Access Compliance Report

Public Rights-of-Way

Intersection ID: 50592	Main Street: BENDING_BRANCH_RD	Cross Street: BRISTLEY_RD	Location: NE
ADA ID: AF15132DBCE4	Ramp Type: Perp	Initial Pass/Fail: Fail	Overall Compliance: No
Severity Score: 25			
Codes/Mitigation Info/Possible Solution		Field Measurements/Component Compliance

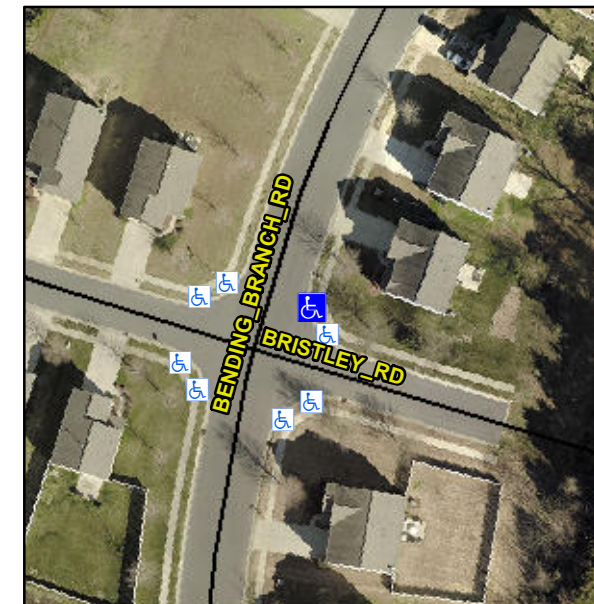
Not Found, R304.5.3

Compliance	Description	Data	Compliance	Description	Data
N/A	Ramp Length (in)	47.5	Yes	Ramp Slope (%)	7.7
Yes	Ramp Width (in)	48.0	No	Ramp XSlope (%)	7.4
N/A	Flare Type LT	N/A	N/A	Flare Type RT	N/A
N/A	Flare Slope LT (%)	N/A	N/A	Flare Slope RT (%)	N/A
N/A	Flare Traversable LT?	N/A	N/A	Flare Traversable RT?	N/A
N/A	Landing Length (in)	N/A	N/A	DWS Provided?	N/A
N/A	Landing Width (in)	N/A	N/A	DWS Contrast?	N/A
N/A	Landing Slope (%)	N/A	N/A	DWS Length (in)	N/A
N/A	Landing X Slope (%)	N/A	N/A	DWS Full Width?	N/A
N/A	Landing Curb? (Y/N)	N/A	N/A	DWS Offset (in)	N/A
N/A	Shared Landing?	N/A			
N/A	Gutter Ponding?	N/A	N/A	Gutter Slope (%)	N/A
N/A	Gutter Lip Ht (in)	N/A	N/A	Gutter X Slope (%)	N/A
N/A	Painted X Walk1?	No	N/A	Painted X Walk2?	N/A
	X Walk 1 Direction	To NW		X Walk 2 Direction	N/A
N/A	X Walk 1 Width (in)	N/A	N/A	X Walk 2 Width (in)	N/A
	X Walk 1 Slope (%)	1.7		X Walk 2 Slope (%)	N/A
	X Walk 1 X Slope (%)	4.5		X Walk 2 X Slope (%)	N/A

Remove & Replace Entire Ramp.
